Site Plan Comments:

ZC-15-070

FIRM REGISTRATION NO. F-4313
 CITY OF FORT WORTH
 SLEEP INN HOTEL
 ~6300 I-35W NORTH
 SITE PLAN
 ZONING CASE #: ZC-015-070
 GRANT ENGINEERING, INC.
 ENGINEERS SURVEYORS PLANNERS
 3244 HEMPHILL FORT WORTH, TEXAS 76110 817-923-3131
 DESIGNED BY: _____ JOB NO. _____
 CHECKED BY: _____ DATE: 5-11-15 10634 SHEET

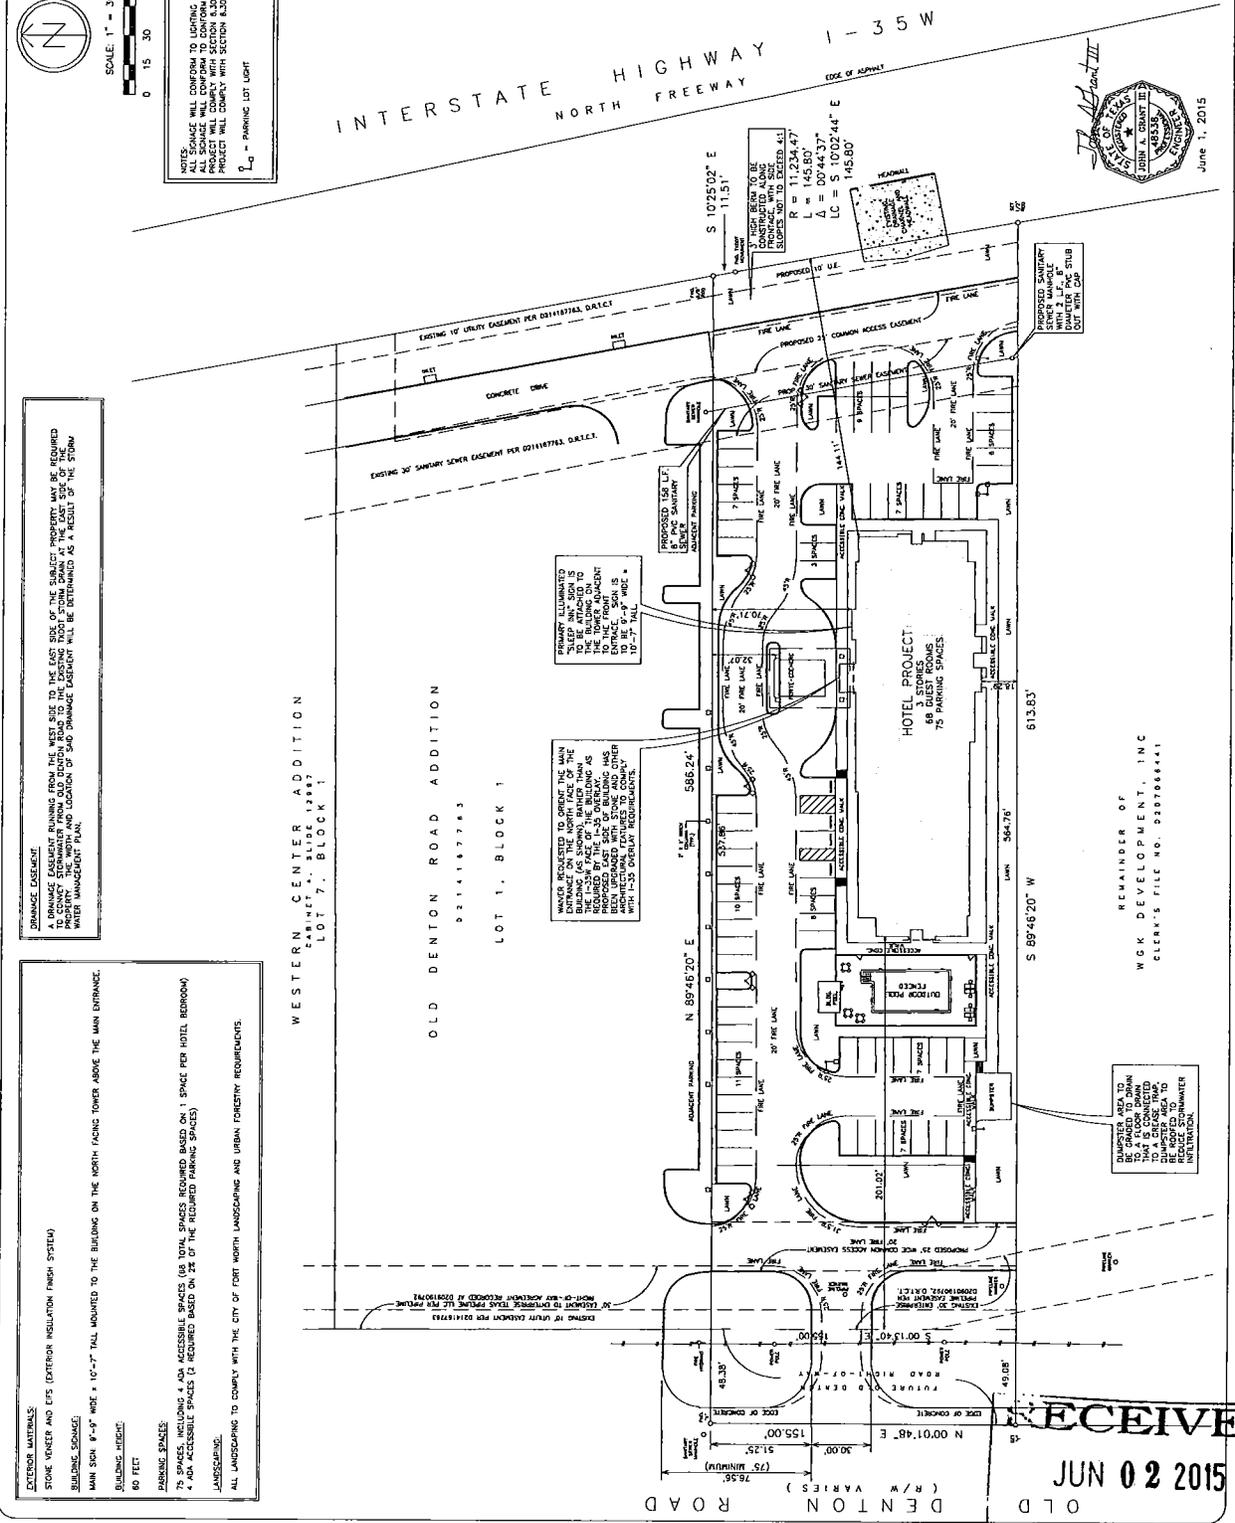
The site plan as submitted is not in general compliance with the Zoning Ordinance regulations. The key deficiencies are:

1. Add location of wall mounted lighting.
2. Provide location of sign (if larger than allowed, then provide the dimensions)
 - a. 10 percent of the façade (most likely doesn't meet attached signage)

Items noted above shall be reflected on the site plan or waivers are required,

1. Public Access Easement - Access easements shall comply with the requirements of Section 31-106 (Street Standards) I (Access Easement Design Standards (Public Access Easements, Reciprocal access Easements, Private Drives or Ways) of the Subdivision Ordinance. Access easements are privately maintained but constructed to city street standards that are open to unrestricted and irrevocable public access and serve two or more lots each having a minimum of 100 feet of frontage as their primary means of access. Show the boundary of the proposed cross access easements as Old Denton Road Addition subdivision did not dedicate any access easements with the project.

2. Driveway location must not interfere with intersection function. The lot as shown does not have access to a public street/private street or public access easement. Show the location of the driveway(s) that connect to a public street, private street or public access easement.

3. Show the dimensions of all existing or recorded streets, alleys, easements, railroad ROW, or other public ROW within or adjacent to the subdivision boundaries. The distance from the centerline of the existing roadway of the boundary street to the proposed property line shall be shown.

4. ROW Dedication: Partial - Dedicate ½ of {80} ' ROW for {Old Denton Rd}
5. Variable ROW - Show the full ROW widths for all existing streets. For streets having variable ROW, call out the ROW as "Variable" and give "Range" of the ROW.

6. Freeway ROW - Call out all freeway ROW. Show distance from property line to centerline of freeway. For a freeway having a variable ROW, call out the ROW as "Variable" and give the "Range" of the ROW. TXDOT approval required for proposed interchange.

7. Property Location - Show distance(s) from property corner(s) to nearest identifiable street, railroad or other intersection.

8. TXDOT Permit - TXDOT permit is required for work in and along State ROW. Street connections to TXDOT ROW contingent upon TXDOT approval.
9. Private Utility Access Agreement - Submittal of an access agreement to TPW is required to allow vehicular traffic to cross private utility ROW or easement.
10. Sidewalks - Sidewalks and street lights are required for all public and private streets and public access easements as per City of Fort Worth Standards.
